SECTION J PART J4 PERFORMANCE-BASED DESIGN BRIEF (PBDB)

OPAL BAYVIEW GARDENS RACF

DOCUMENT No.: 240516
DOCUMENT TITLE: Opal Bayview RACF
NCC 2022 Section J Building Fabric Requirements
DOCUMENT REV: D
DOCUMENT BY: J.B DATE: 04/08/2025

A103 LEVEL 1
SCALE: 1:200
0 5.0M 10.0M

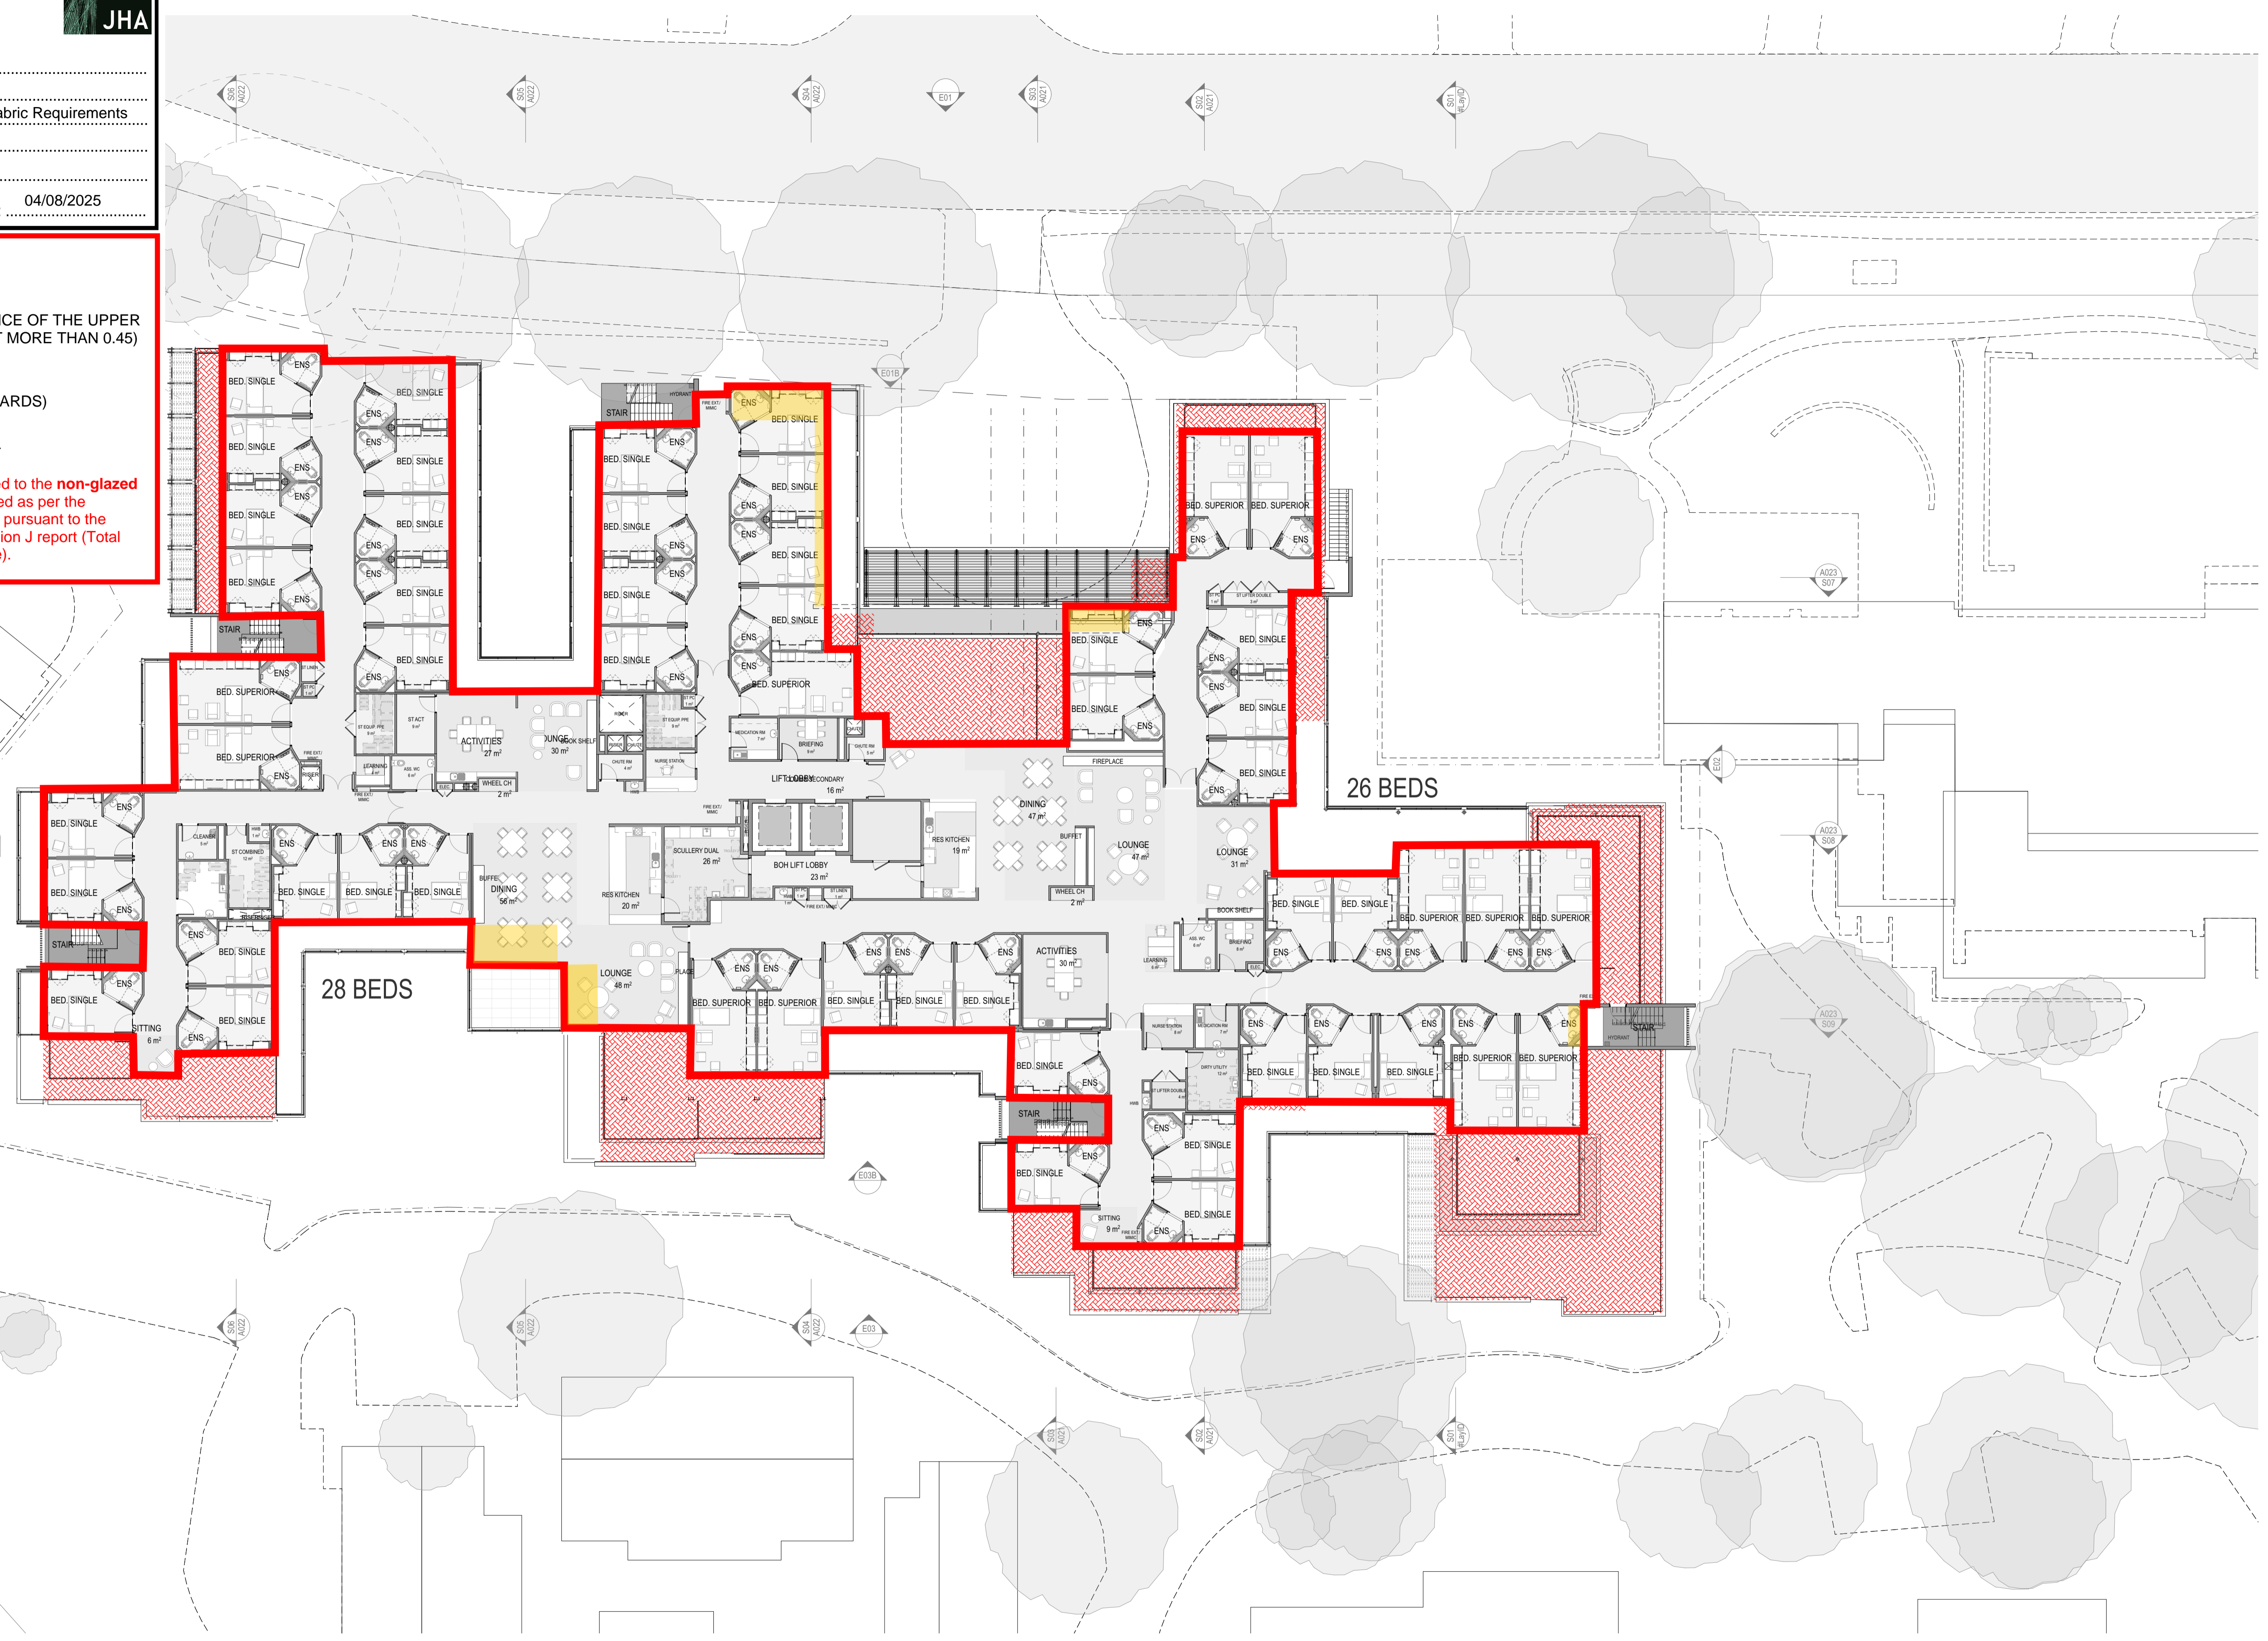
ROOF/EXPOSED CEILING - R3.7
(DOWNWARDS, SOLAR ABSORPTANCE OF THE UPPER SURFACE OF A ROOF MUST BE NOT MORE THAN 0.45)

ENVELOPE FLOORS - R2.0 (DOWNWARDS)

EXTERNAL ENVELOPE WALLS - R1.4

Note: The above construction are only to be applied to the **non-glazed portions of the envelope**; glazing must be installed as per the architectural layouts with its thermal performances pursuant to the respective glazing specifications stated in the Section J report (Total Systems U-Value, and Total Systems SHGC value).

A104 LEVEL 2
SCALE: 1:200
0 5.0M 10.0M

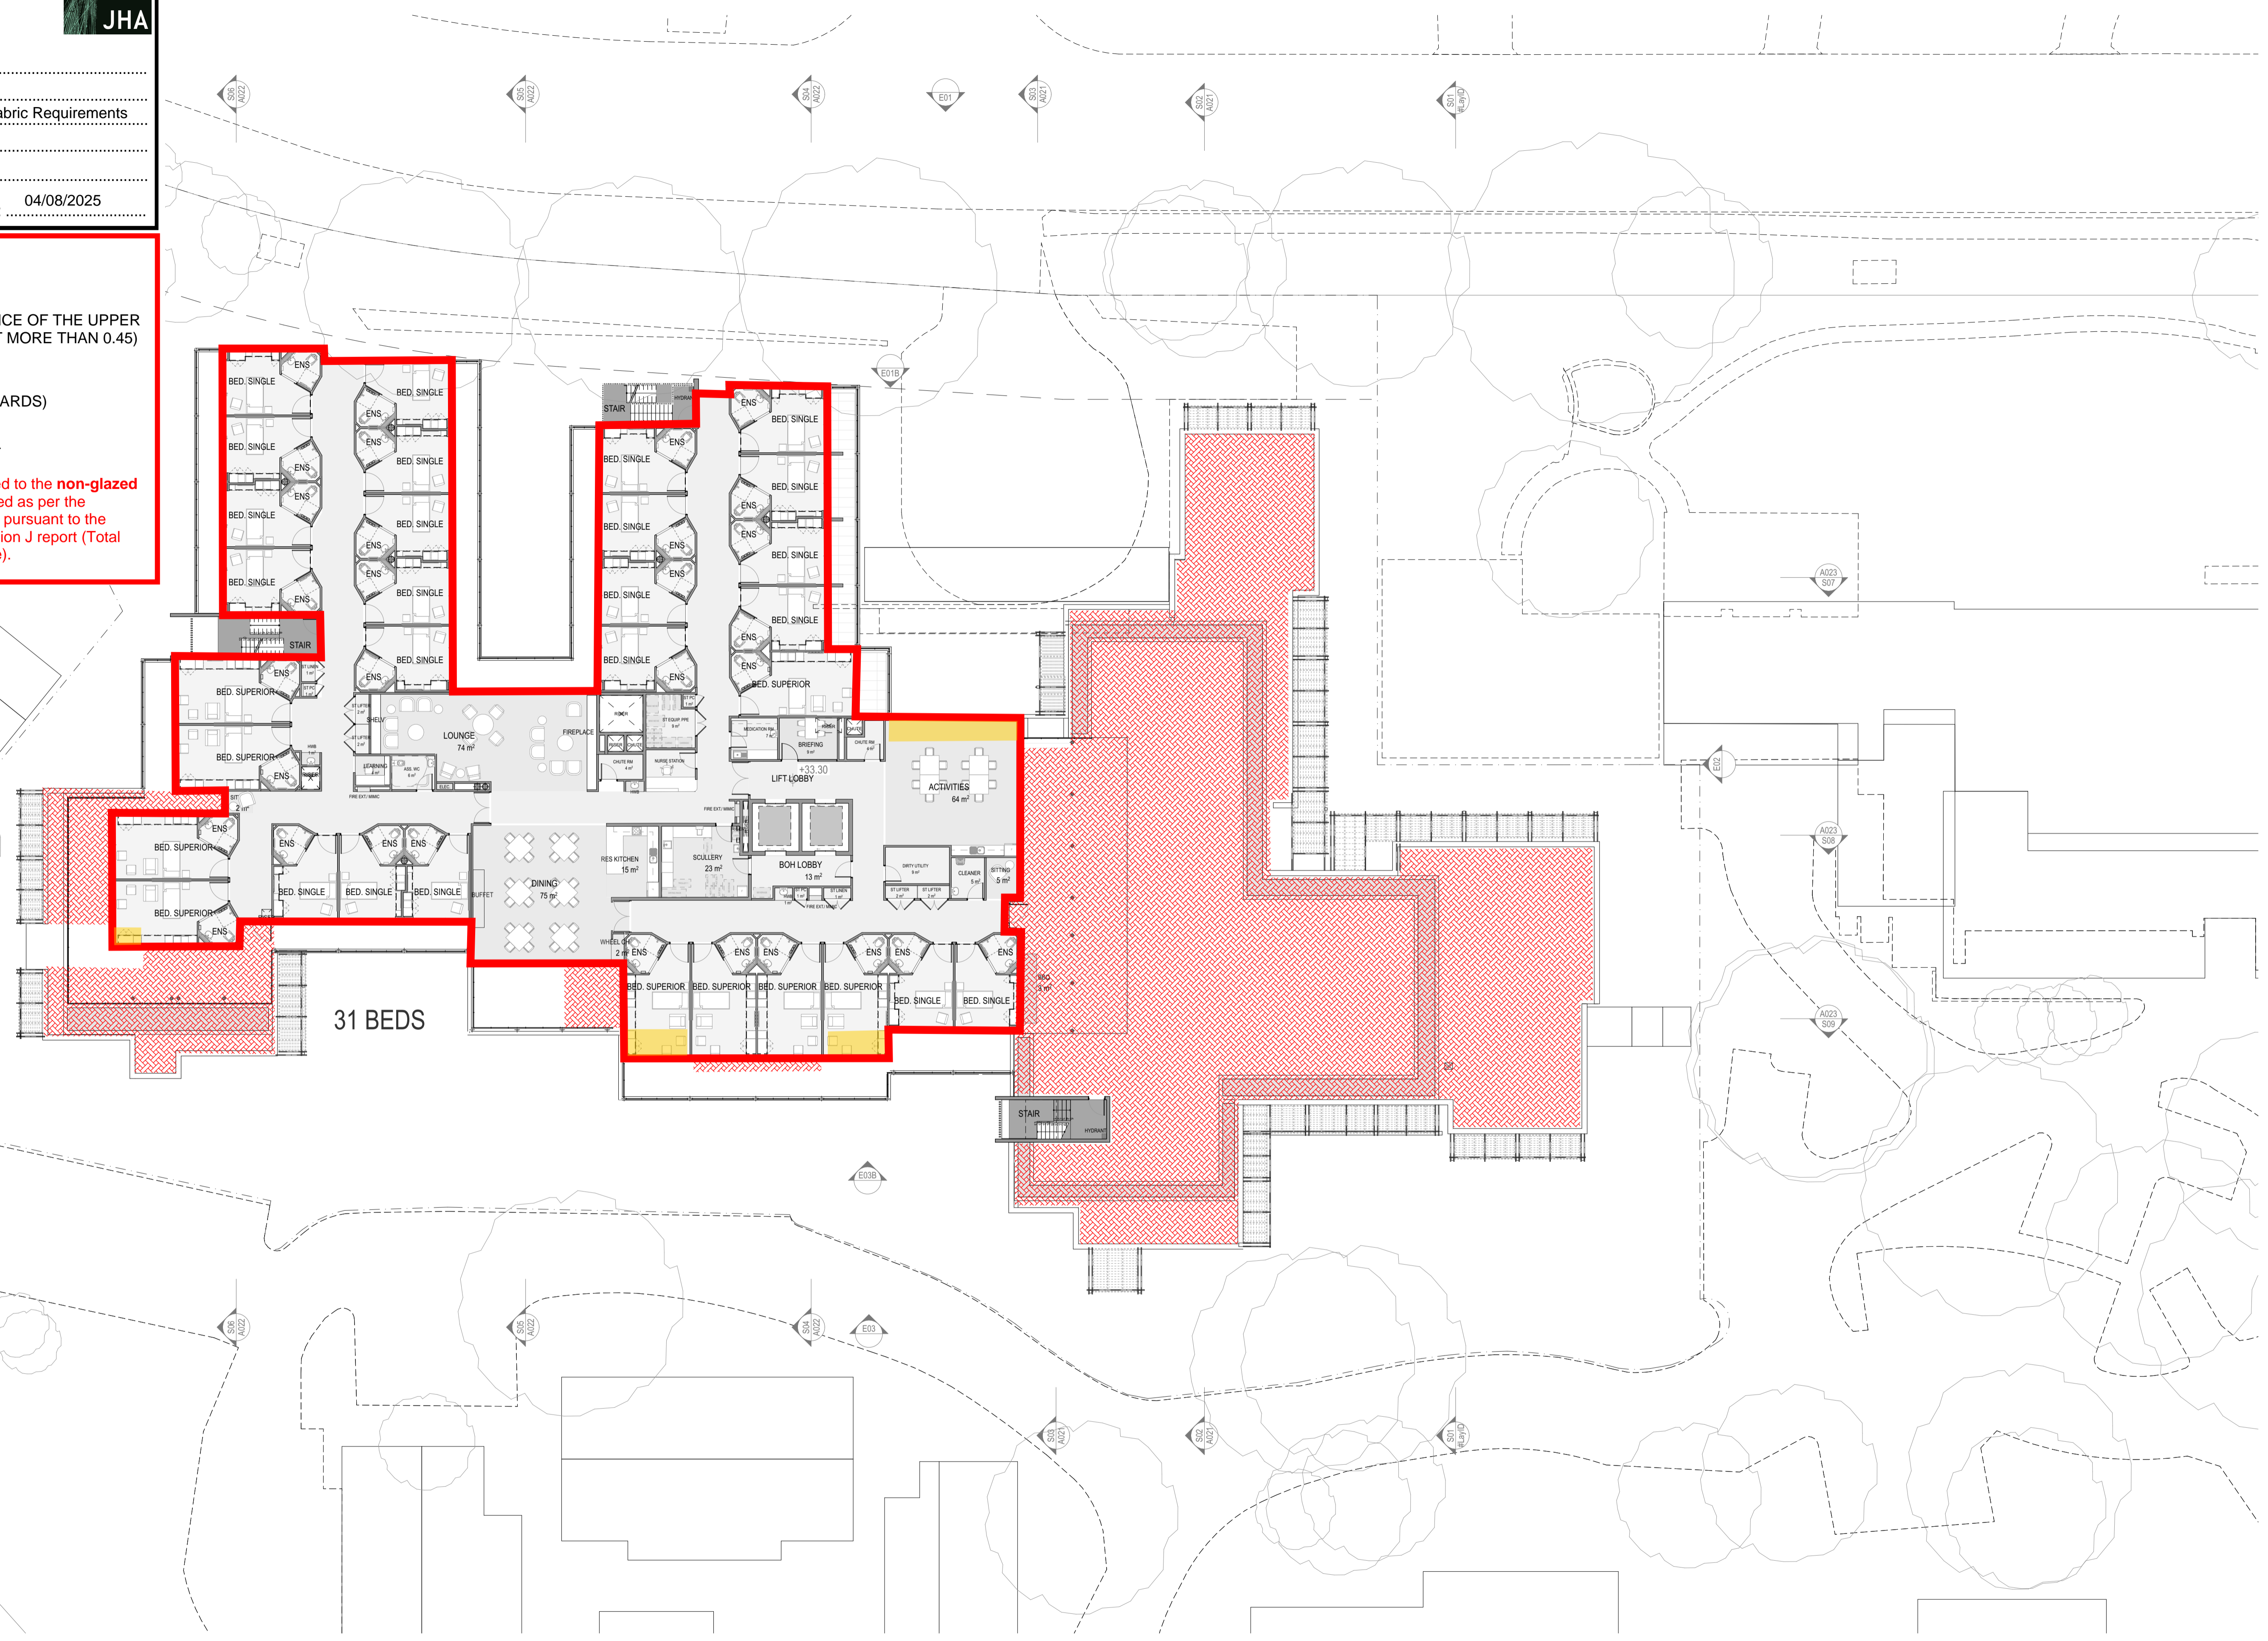
ROOF/EXPOSED CEILING - R3.7
(DOWNWARDS, SOLAR ABSORPTANCE OF THE UPPER SURFACE OF A ROOF MUST BE NOT MORE THAN 0.45)

ENVELOPE FLOORS - R2.0 (DOWNWARDS)

EXTERNAL ENVELOPE WALLS - R1.4

Note: The above construction are only to be applied to the **non-glazed portions of the envelope**; glazing must be installed as per the architectural layouts with its thermal performances pursuant to the respective glazing specifications stated in the Section J report (Total Systems U-Value, and Total Systems SHGC value).
